**Evaluation of  
San Bernardino Valley  
Municipal Water District**

**THREE DAM PROPOSAL**

**Upper Santa Ana River & Mill Creek**

September 1982

SANTA ANA RIVER BASIN, CALIFORNIA
UPPER SANTA ANA RIVER AND MILL CREEK THREE DAM PROPOSAL
<b>FORKS DAM SITE PLAN</b>
US ARMY CORPS OF ENGINEERS LOS ANGELES DISTRICT

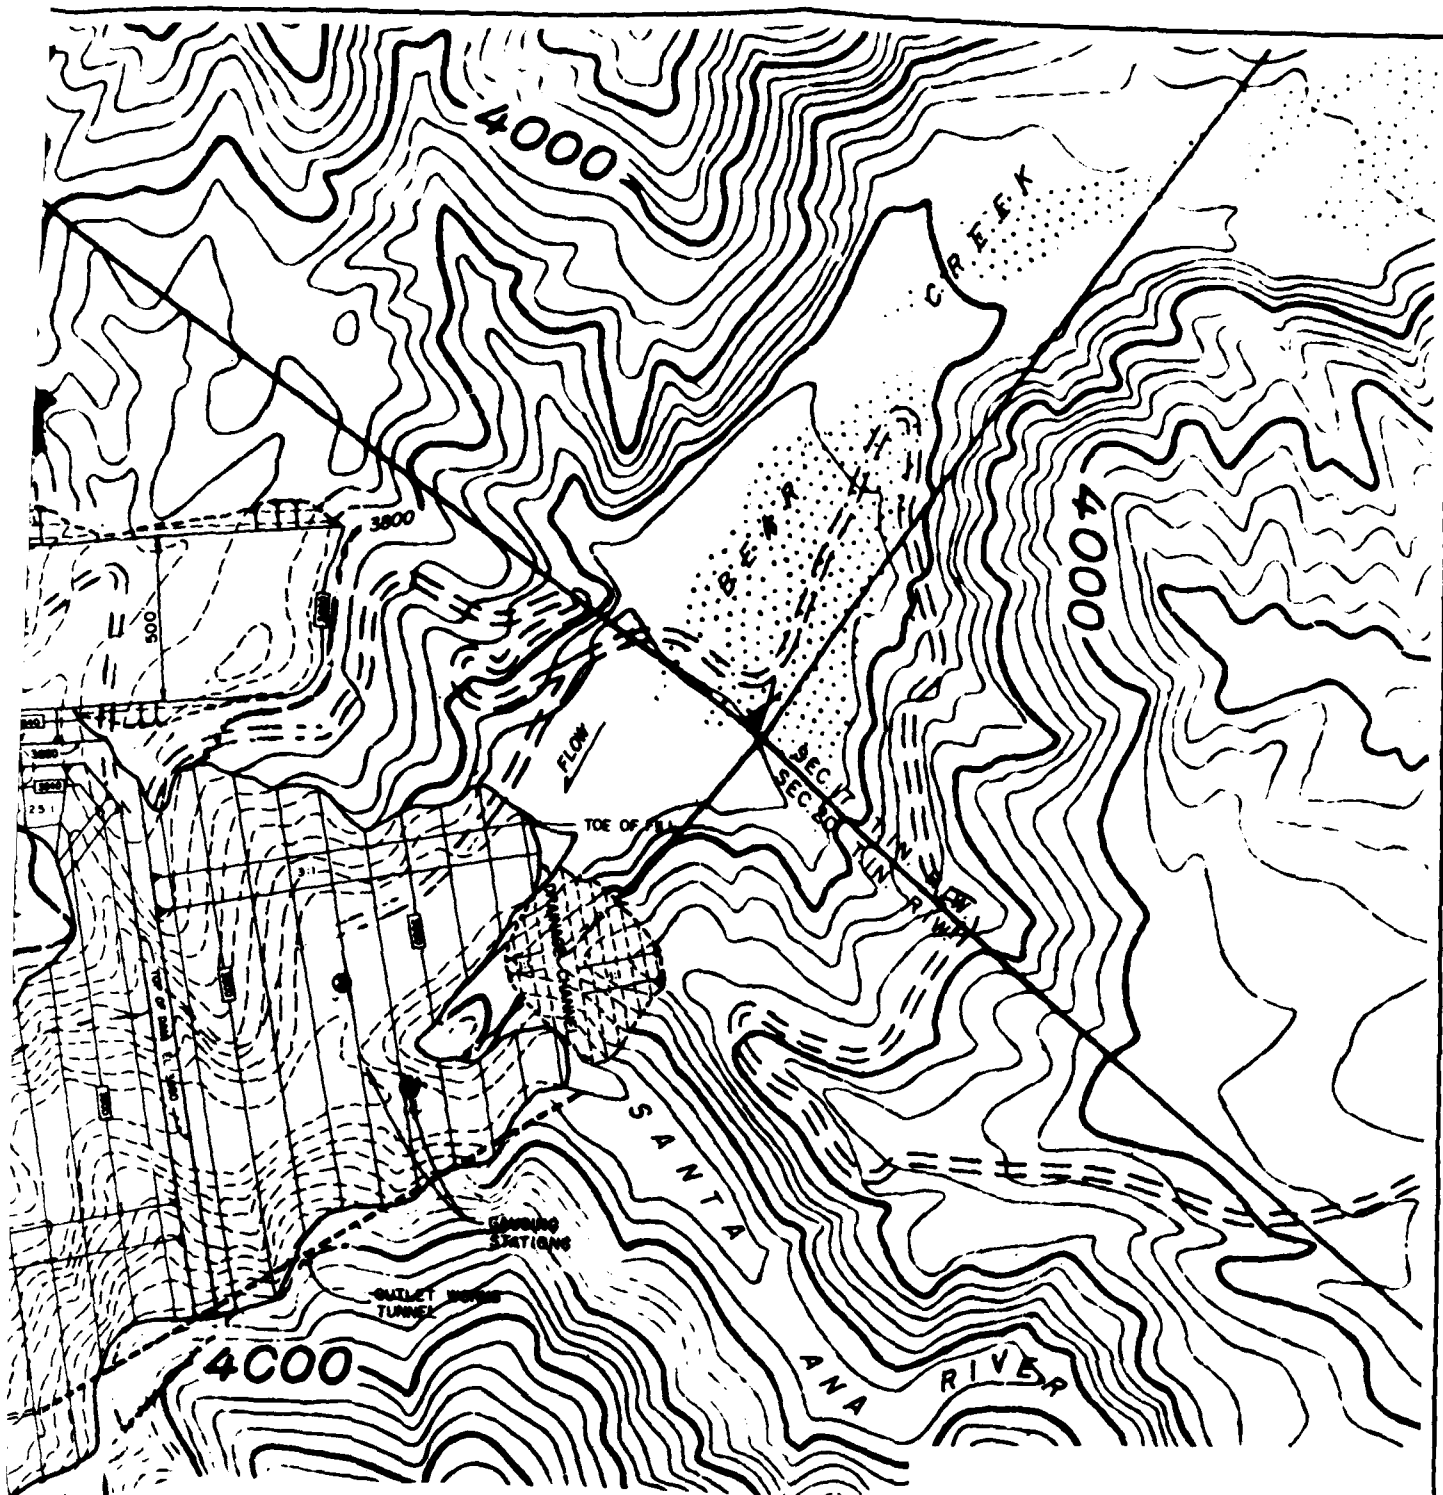
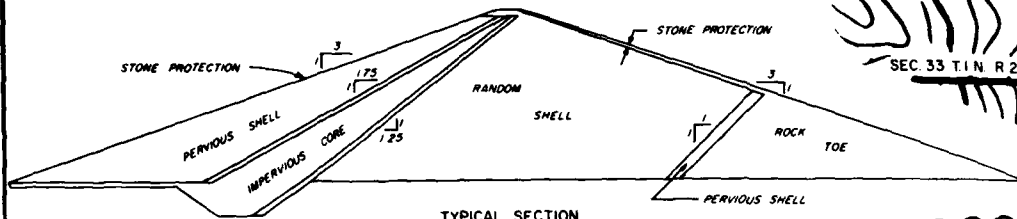
Upstream Site (Streambed Elevation 3400). Both gravity concrete (including rollcrete) and earthfill dams were considered. As stated in the geological evaluation of this site, above elevation 3800 the abutment material

changes from relatively incompressible granite to unconsolidated sediments. The compressible, unconsolidated sediments extend for a considerable distance from the surface. The differing deformation characteristics of the abutment material renders the site unacceptable for a 460-foot high concrete dam. An earthfill embankment at the same location would be acceptable although construction would encounter a restrictive work area from streambed elevation to approximately 200 feet above streambed, where the width is approximately 100 feet and slopes are steep. For an earthfill structure conservative assumptions for foundation treatment including considerable scaling and abutment shaping would be made to account for uncertainties in the condition of the bedrock. The upstream slope toe would also place fill in Bear Creek and Santa Ana Canyon and excavation of a drainage channel would be required. Spillway length would be approximately 2600 feet. The dam crest length would be approximately 1450 feet.

(a) Dam. The upper Forks site (Elevation 3400) was selected for an earthfill structure over the lower Forks site on the basis of estimated construction costs. See plate 7.

(b) Spillway. Spillway locations were evaluated in both the east and west abutments. Because of the steep relief of the east abutment, spillway excavation requirements would be unacceptably high. The most suitable spillway site is on the west abutment where slopes are moderate, so significantly less spillway excavation would be required. The spillway site appears to be located predominantly in older alluvial terrace deposits consisting of sands and gravels and would be concrete lined upstream of its crest. It is assumed that "competent" bedrock would be encountered at the crest and concrete lining would not be needed downstream from the crest. Because sediment would occupy a substantial part of overall reservoir storage, spillway flow would occur frequently. Spillway channel excavation and embankment toe protection would be required. Spillway flow characteristics and geologic conditions would be a significant detailed design consideration and could require substantial site modification.

(c) Outlet Works. Although geotechnical conditions are suitable on either side, the east abutment was selected for the outlet works alignment, primarily on the basis of minimum length. A hydropower outlet would be incorporated into the outlet works. The ten foot diameter tunnel would be used for diversion and control of water during construction and would be subsequently gated for operational use. Access to the gate chamber would be through a vertical tower and control house on the crest of the dam. A vertical intake shaft would be provided to the outlet conduit on the abutment slope to permit the outlet works to remain operational as sediment accumulates within the reservoir area. Maximum sediment deposition, based on elevation/capacity relationships, would be about 300 feet.

NOTE ALTERNATE ALIGNMENT AT  
STREAM BED ELEVATION 1980  
CORRESPONDS TO APPROXIMATE  
ALIGNMENT SHOWN IN BULLETIN  
19

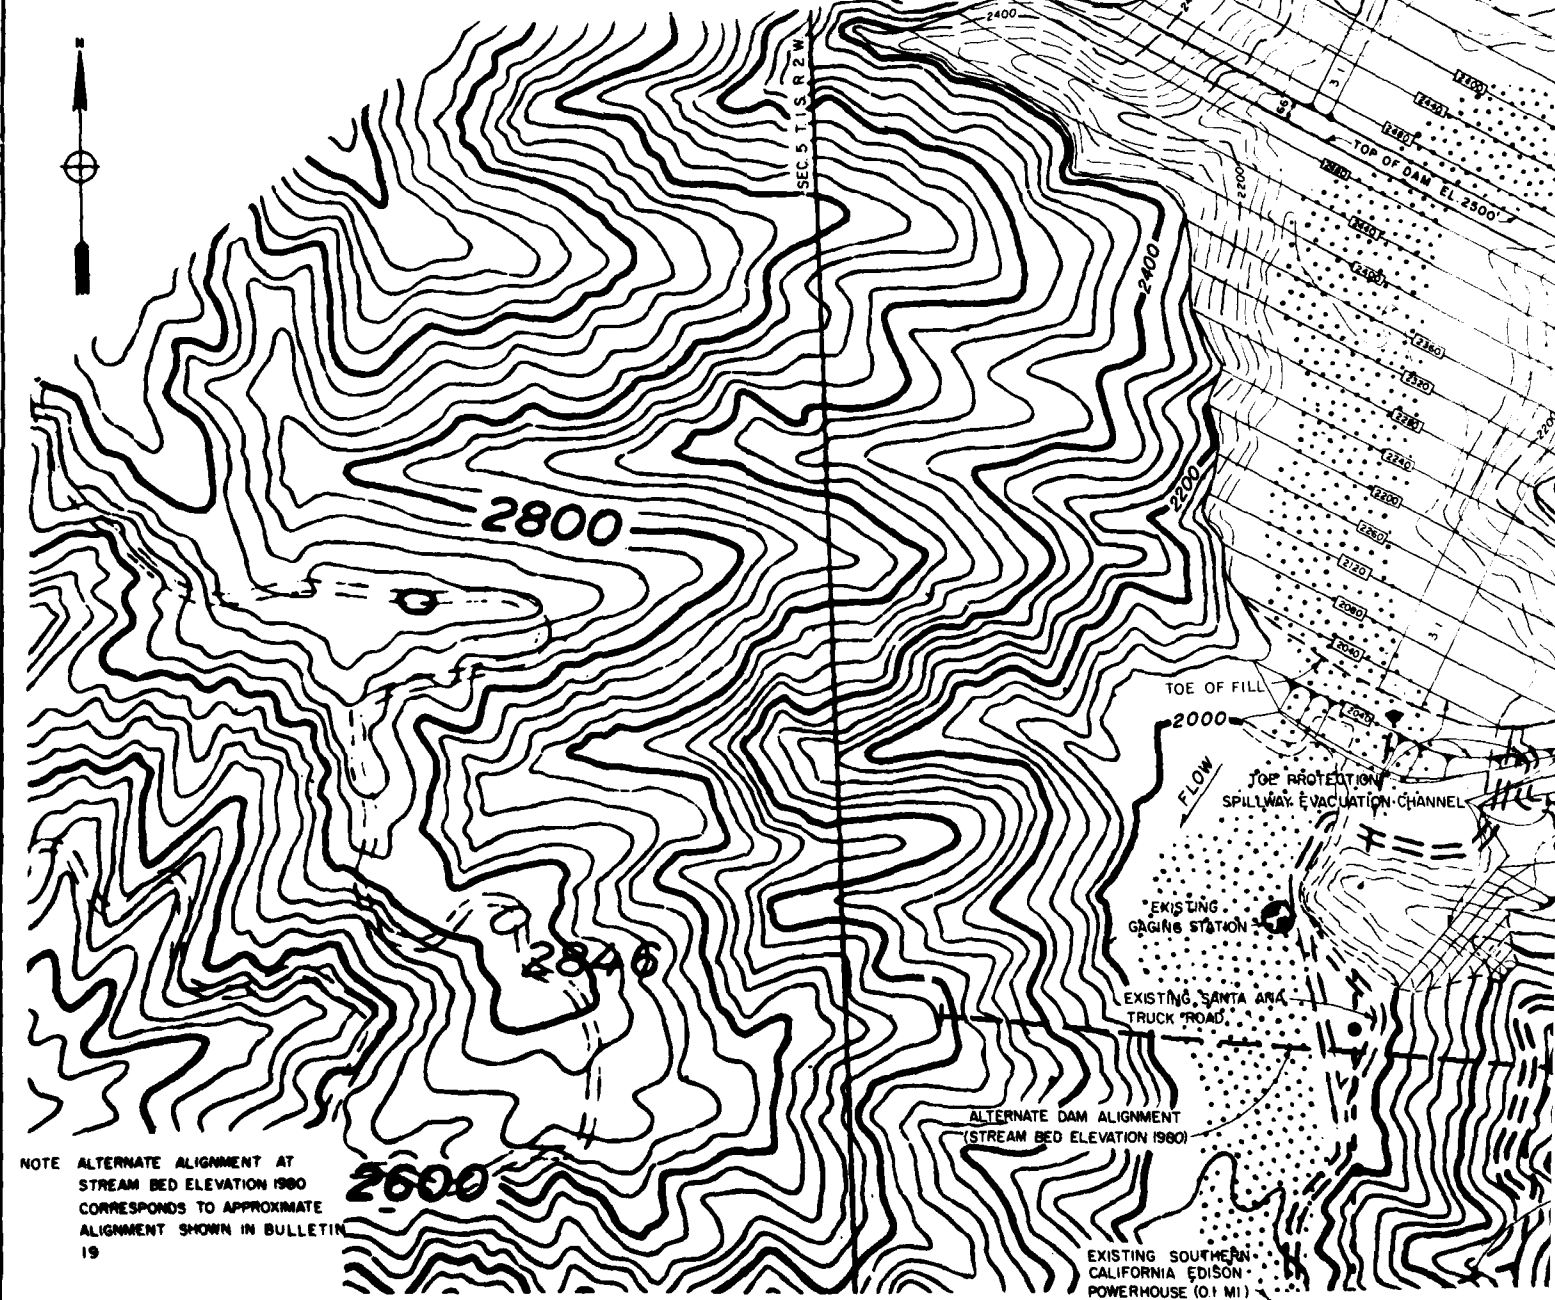
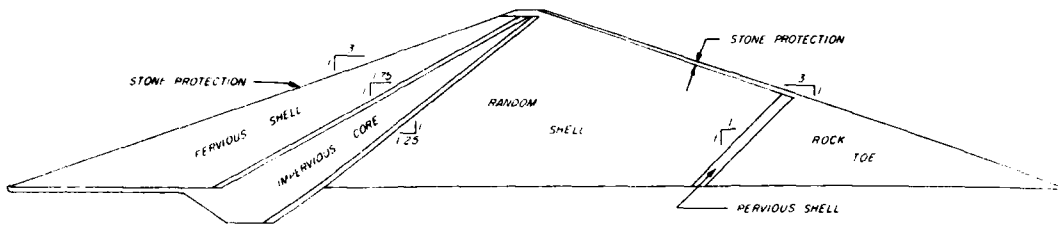
(Dam at Streambed Elevation 1980.) This site was placed at the approximate location shown in Bulletin 19. A concrete and an earthfill dam were considered. The rock type is massive, intact granite with few major joints. Streambed alluvium is estimated to be at a depth of 200 feet so a positive cutoff to bedrock would be precluded. The canyon is about 600 feet wide with moderately steep slopes to approximately 1800 feet above streambed. Adjustments in the embankment alignment immediately upstream would have nominal effect on quantities of embankment and spillway excavation material. Siting the embankment downstream would impact an existing Southern California Edison powerhouse. Because of the depth of alluvium, which would preclude excavation to bedrock, concrete structures were not considered suitable at this location. The site, however, is suitable for an earthfill structure.

(Dam at Streambed Elevation 2060.) Rock type characteristics and alluvium depths are similar to those at the lower site. Both earthfill and concrete (including rollcrete) dams were considered. Because of the depth of alluvium, which would preclude excavation to bedrock, concrete structures were not considered suitable at this site. A saddle located at the east side provides a more suitable spillway site than would be available at downstream locations. Adjustments in the embankment alignment immediately downstream would increase the volume of embankment required and would encroach on the spillway flow. Adjustment in the embankment upstream would cause increased blockage in Government Canyon and the length of the outlet tunnel would have to be increased. A power line crossing the reservoir area would be relocated. An excavated channel would be provided at the upstream toe of the dam to drain Government Canyon which would be partially blocked by the embankment.

(a) Dam. The upper site (elevation 2060) was selected for an embankment because topographic characteristics provide a more economical spillway and outlet works location than the lower site. A lower elevation saddle on the east abutment permits significantly less excavation than at the downstream site (elevation 1960). See plate 8.

(b) Spillway. At the streambed elevation 2060 dam site, the saddle near the east abutment provides the most suitable spillway location. The downstream site would require more extensive excavation in the steep canyon walls. The spillway flow would affect the toe of the embankment; spillway channel excavation and embankment toe protection would be required. A rock knoll located in the streambed downstream of the spillway would also be excavated to facilitate conveyance of spillway flows away from the toe of the dam. Spillway flow characteristics in relation to the dam would be a significant detailed design consideration.

(c) Outlets Works. An alignment through the east side was selected as the shortest and most economical outlet works location. A ten-foot diameter tunnel would be used for diversion and control of water during construction and would be subsequently gated for operational purposes. Access to the gate chambers would be through a vertical tower and control house on the crest of the dam. Detailed design would have to address impacts of spillway flow on the downstream portal of the outlet works.
